PUBLIC UTILITIES COMMISSION

Subject: Crazy Horse Canyon Switching Station Project—Review of Minor Project Modification #10

Modification #10: Access to Compensatory Wetland Mitigation Site.

Wetland Mitigation
Crazy Horse Canyon Switching Station Project

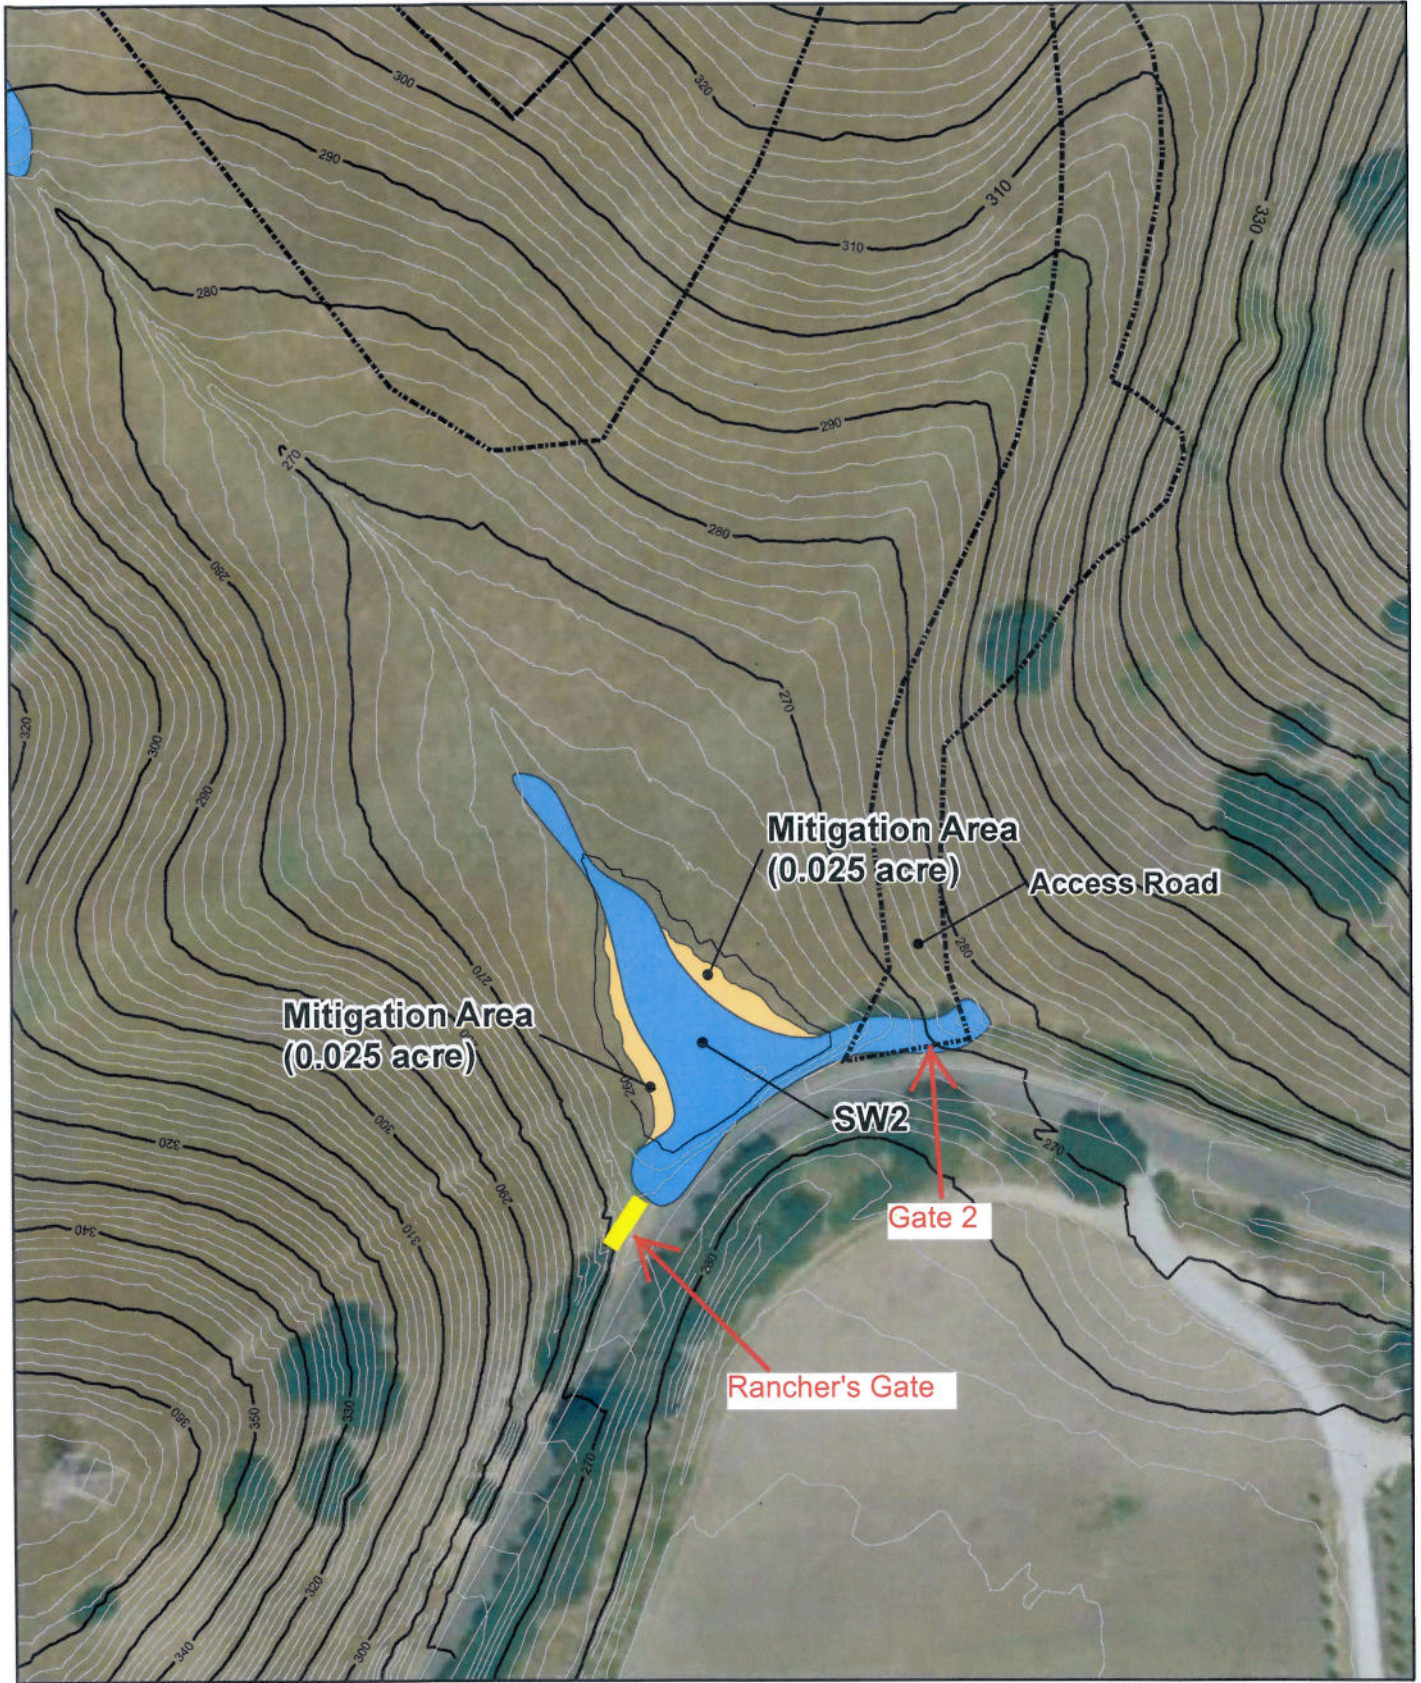
PG&E will use an approximately 0.4-acre work area surrounding Seasonal Wetland 2 (SW2) adjacent to the Switching Station entrance gate ("Gate 2") on San Juan Grade Road and the permanent access road (shown on Attachment A) in order to construct 0.05 acre of new compensatory wetland on site, as described in the Wetland Mitigation Monitoring Plan (WMMP). The WMMP was developed through consultation with United States Army Corps of Engineers (USACE), Regional Water Quality Control Board (RWQCB), the California Department of Fish and Wildlife (CDFW). The wetland mitigation is required by the 404 Permit, 401 Water Quality Certification, Streambed Alteration Agreement, and Applicant Proposed Measures (APMs) Biology-11 and Hydrology-2. Of the total 0.4-acre work area, 0.35 acre would be temporarily used to access and maneuver equipment to create 0.025 acre of wetland on either side of SW2 (totaling the required 0.05 acre), and for any additional contouring that is needed to accommodate the topography of the expanded wetland.

Access to the eastern portion of the proposed work area would be from the Gate 2 access road. Access to the western portion of the proposed work area would be through an existing rancher's gate, south of Gate 2 (shown on Attachment A). Equipment to be used in the area would include a rubber-tracked mini-excavator and a bobcat, or similar equipment. Disturbance

The MPM was reviewed to determine whether the proposed action would result in a new significant environmental effect or would substantially increase the severity of a previously identified significant environmental effect. The MPM is consistent with the analysis presented in the IS/MND and additional review under the California Environmental Quality Act is not required.
